DESIGN CP	DRAWN BY CP	DART AEROSPACE LTD HAWKESBURY, ONTARIO, CANADA
CHECKED <i>[initials]</i>	APPROVED <i>[initials]</i>	DRAWING NO. DSI 9311
DATE 05.09.22		TITLE INSTALLATION CHANGE
A	05.09.22	SCALE NTS NEW ISSUE

DART SERVICE INSTRUCTION

TO AMEND INSTALLATION INSTRUCTIONS IIN-D350-689 REV. A

REF. CANADIAN STC: SH02-33

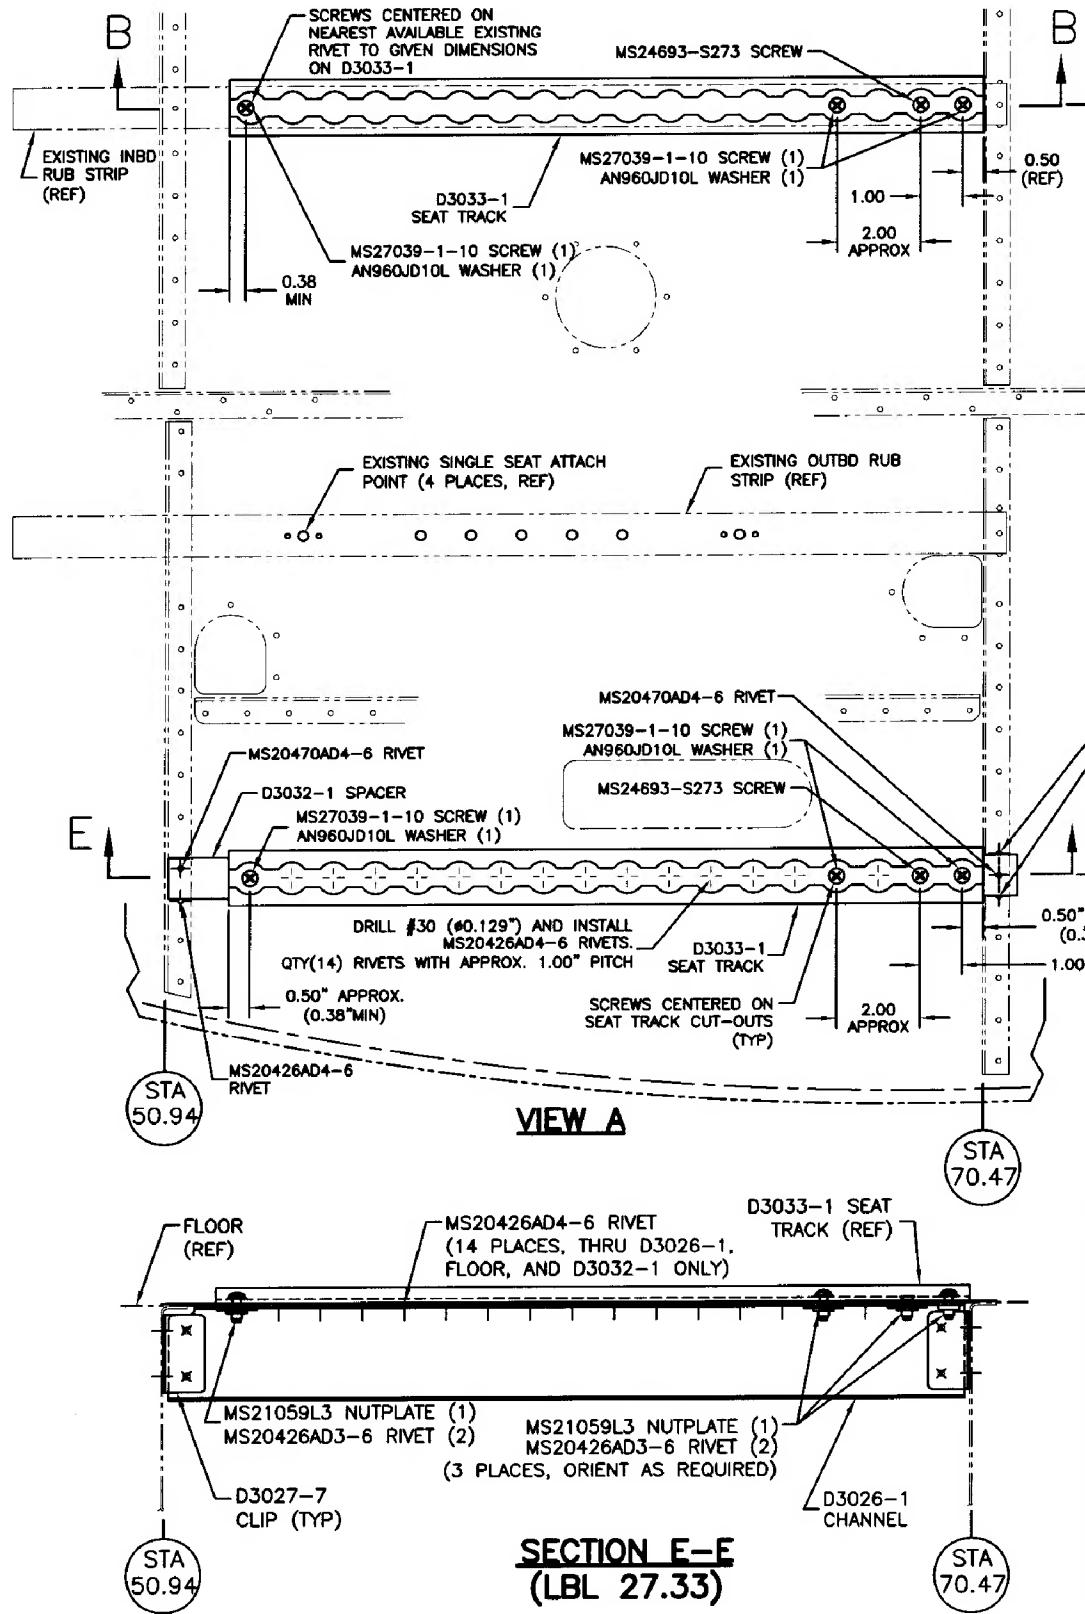
On some aircraft, the holes in the D3026-1 Channel conflicted with existing holes in the floor when there is an existing stringer at LBL 27.33. To prevent this from happening, the holes have been removed from the D3026-1 Channel and it will be required that the customer locate the rivets holes depending on whether this stringer exists or not. Also, the D3027-1 Clips will be provided without holes and the D3033-3 Seat Track will be replaced with an undrilled D3033-1 Seat Track. The D350-689-013 Floor Provision Kit should be installed per IIN-D350-689 Rev.A with the changes noted below.

- 14) From middle of existing copilot seat inboard rubbing strip, measure 18.35" as shown in Figure 1 of this service instruction and mark for installation of left side D3026-1 Channel.

- 15) If there is an existing stringer at LBL 27.33, it will need to be removed from that location. Locate D3026-1 Spacer as shown in Figure 1 of this service instruction and transfer existing holes from the aircraft floor to the D3026-1 Channel & D3032-1 Spacer. Ensure 1.0" to 1.5" rivet pitch and add additional holes if required. If there is no existing stringer, locate D3026-1 Channel & D3032-1 Spacer as shown in Figure 1 of this service instruction and drill Ø0.128" holes on a 1.0" to 1.5" pitch.

- 16) Remove existing rivets at STA 50.94 (1294mm) and 70.47 (1790mm) that interfere with installation of seat tracks (refer to Figure 1 of this service instruction).

- 19) Locate the aft ends of D3033-1 Seat Tracks at STA 70.47 (1790mm) as shown in Figure 1 of this service instruction. One D3033-1 should be centered on the existing inboard rubbing strip, while the other should be 18.53" (470.7mm) to the left.

- 20) Transfer drill Ø0.128 to D3033-1 Seat Tracks (8 places) as shown in Figure 1 of this service instruction. Open seat track and aircraft floor holes to Ø0.191 and countersink hole for MS24693-S273 screw in seat track. Drill Ø0.191 through the aircraft floor. Install MS21059L3 nutplates (8 locations) using MS20426AD3-6 rivets. Install the qty(2) D3033-1 Seat Tracks using the hardware shown in Figure 1 of this service instruction.
